# Branch Street School

City of Methuen  
ADA Transition Plan

November 2024

Institute for Human Centered Design

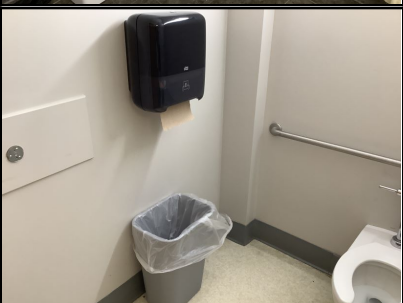
ID	Location	Floor	Room	Element	Type	Photo	Issues	Current Measure	Recommendations	Quantity	Price	Cost Estimation
16	Reception Office/ Corridor	1	125	Doors, Doorways, & Gates	Office		Maneuvering clearance(s) not provided	-	Relocate the bags and table to provide 12" of push side maneuvering clearance and 48" min. between the table and the wall on the latch side of the door.	1	Labor	Labor
17	All-Gender Single-User Toilet Room in School Corridor	1	135	Doors, Doorways, & Gates	Toilet Room		Maneuvering clearance(s) not provided	16"	Provide an automatic door opener.	1	6000	\$6000
											6000	
18	Playground Entrance	Ext.	-	Doors, Doorways, & Gates	Circulation		Threshold not maintained in operable working condition		Repair the cracks in front of the threshold.	1	-	-
19	Administratio n Office Corridor	1	-	Doors, Doorways, & Gates	Circulation		Door requires > 5 lbs. of force to open	13 lbs	Adjust closers so doors do not require more than 5 pounds of force to open.  Applies to all doors in this condition.	1	Labor	Labor

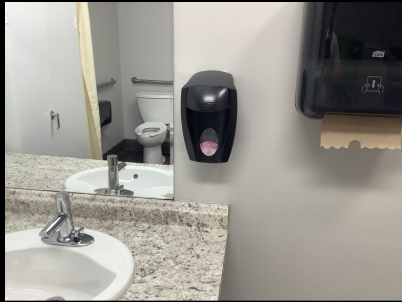
Elevator												
20	Elevator	1	-	Elevator	Interior		Tactile stars not provided at main entry level	-	Provide a tactile star on both sides of jambs at main floor. At other floors, provide appropriate number.	2	96	\$192
											192
